PLANNING COMMISSION AGENDA

December 16, 2010

29. **SDR-40146 - SITE DEVELOPMENT PLAN REVIEW - PUBLIC HEARING - APPLICANT: THE SMITH CENTER - OWNER: CITY OF LAS VEGAS** - Request for a Major Amendment to a previously approved Site Development Plan Review (SDR-26709) FOR A PROPOSED FIVE-LEVEL, 335-SPACE PARKING GARAGE WITH WAIVERS OF THE SYMPHONY PARK PARKING STRUCTURE DESIGN STANDARDS, BUILD-TO LINE STANDARD, REQUIRED RETAIL FRONTAGE STANDARD AND STREETSCAPE STANDARDS on a portion of 5.10 acres at the northeast corner of Clark Avenue and Promenade Place (APN 139-33-610-026), PD (Planned Development) Zone, Ward 5 (Barlow). Staff recommends DENIAL.

SHEET NO
GA5.01

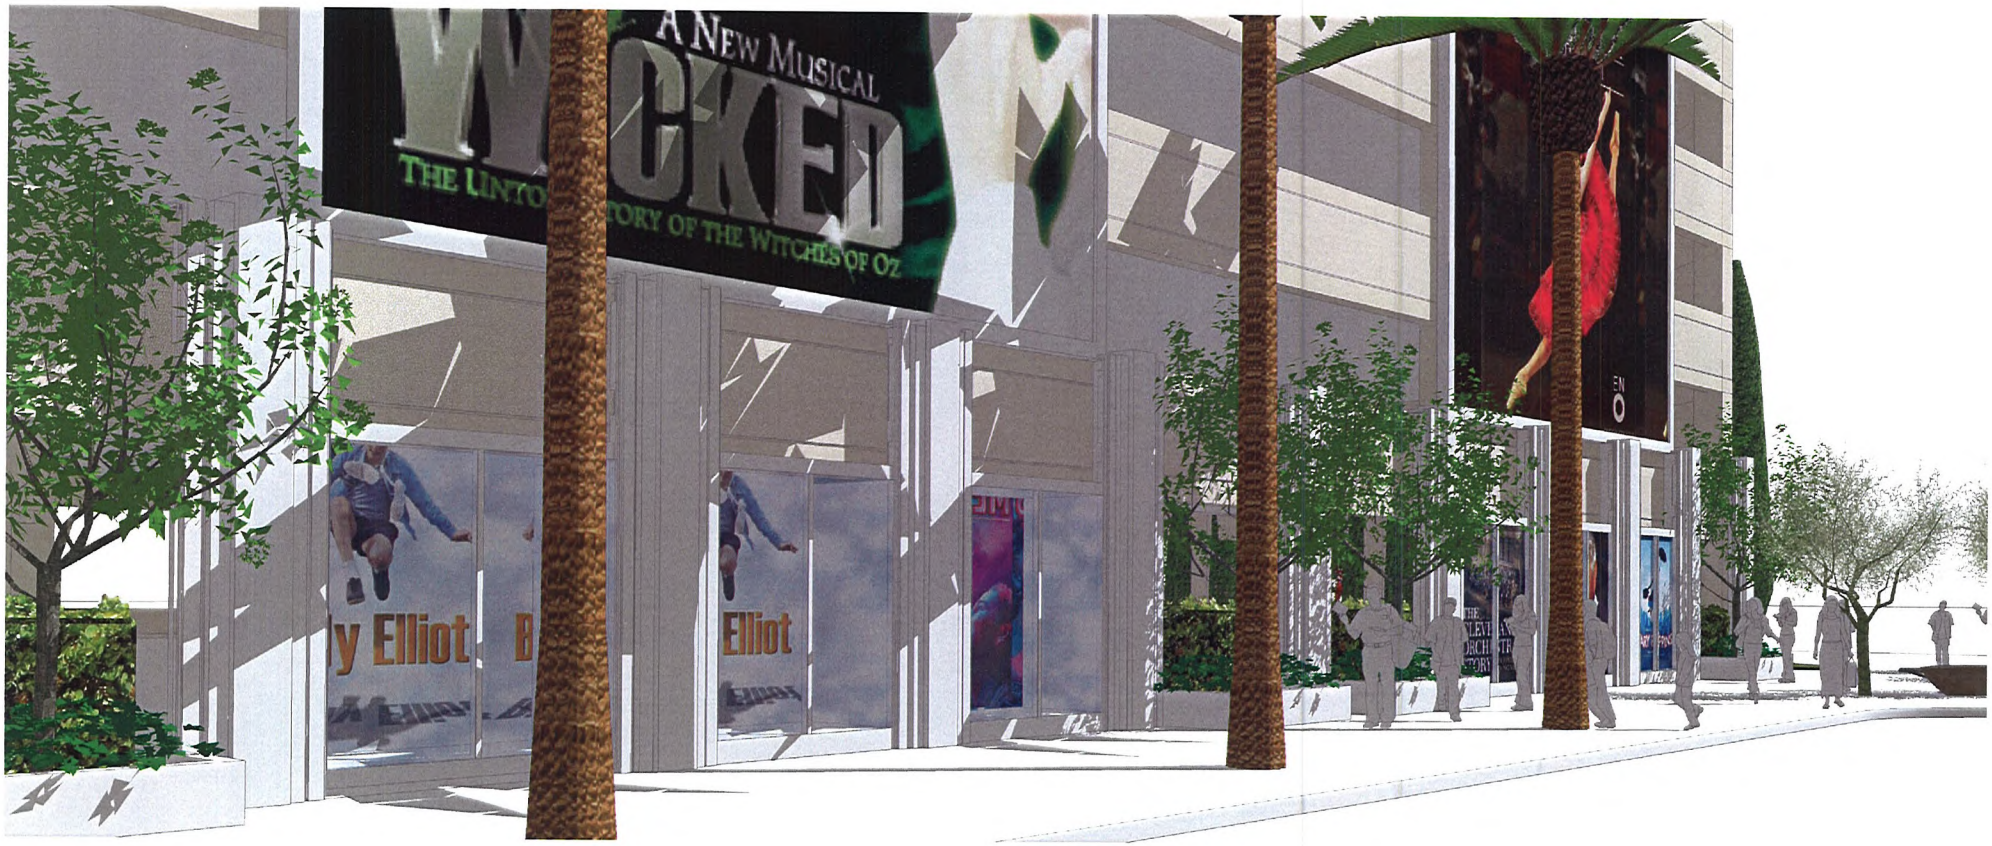
1. The Garage elevations shown on Sheet GA5.01do not reflect any of the last set of comments from the SP-DRC and are found to be lacking the quality of architecture required for them to be approved per the Design Standards. If approved anyway, the following Sections of the Required Design Standards would have to be waived, presented here with a parenthetical note of how the current project responds.

2. Sheet GA5.01
   a. Provide canopies along the rest of the Promenade Place elevation over the display openings.
   b. Provide an architectural treatment on the West Clark Avenue elevation similar to the Promenade Place elevation
